Paper for Consideration by ENCWG8

S-52 PL 4.0.3 OBSTRN07

| <b>Executive Summary:</b> | This paper seeks to clarify the colour token used to draw dashed lines in the CSP OBSTRN07 when the VALSOU is greater than the safety depth. |

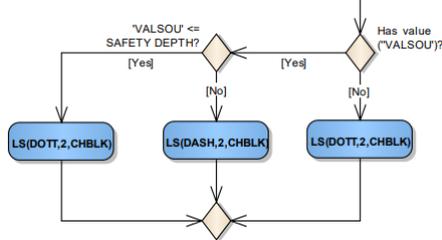
In updating the S-101 portrayal catalogue it was noted that S-52 PL 4.0.3 provides inconsistent guidance in OBSTRN07 when outputting dashed lines. We believe continuation B should be updated to specify use of CHGRD when VALSOU is greater than the SAFETY DEPTH setting.

Continuation B specifies use of colour token CHBLK, regardless of the SAFETY DEPTH:

In continuation C, when VALSOU is greater than the SAFETY DEPTH colour token CHGRD is specified:

It is recommended that in the OBSTRN07 UML diagram continuation B when VALSOU is greater than the SAFETY DEPTH the colour token should be changed to CHGRD.
